Access Compliance Report

Public Rights-of-Way

(Curb Ramps)

Intersection ID: 46671	Main Street: DAMASK_DR	Cross Street: HUNSLET_CR	Location: NE
ADA ID: 31D7809C8E11	Ramp Type: Perp	Initial Pass/Fail: Fail	Overall Compliance: No
		Severity Score: 22.5

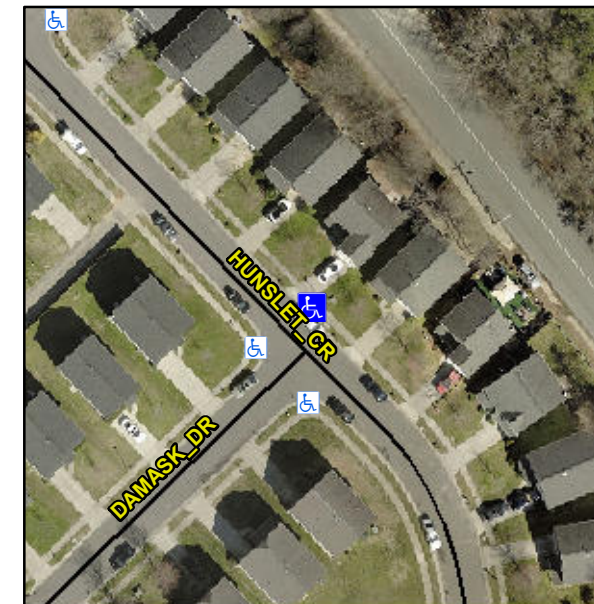
Not Found, R304.5.1, R304.2.2

Remove & Replace Entire Ramp.
